SERVICE BULLETIN

ENGINE - LP COMPRESSOR - CORRECT THE SERIAL NUMBER ON THE REAR RETAINING RING - CATEGORY CODE 6 - MOD.ENG-72-0261

V2500-ENG-72-0261

Location of the Serial Number on the Rear Retaining Ring
Fig.1

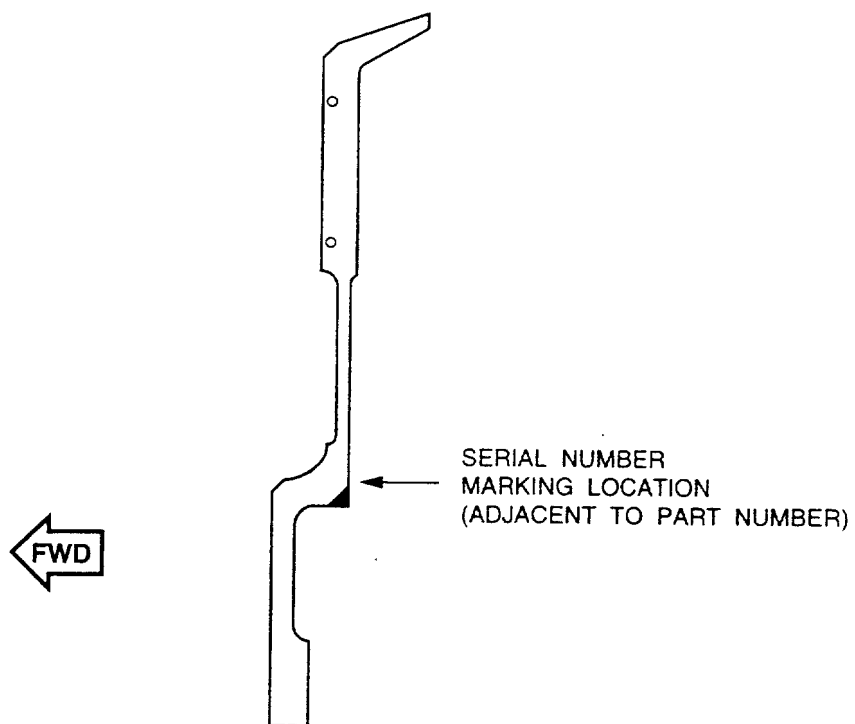
(1) Check the serial number on 5A0897, Rear Retaining Ring (72-31-12,01-100), if the serial number is JI2A087 or JI2A088 or JI2A089 or JI2A090, do the instruction that follows;

(a) Make a mark of the suffix "A" to the ending of existing serial number as follows;

See Figure 1.

JI2A087A
JI2A088A
JI2A089A
JI2A090A

Use the electrolytic-permanent method.

See Reference (2),
Control No./ TASK No.
70-09-00-400-501,
Marking of Parts.
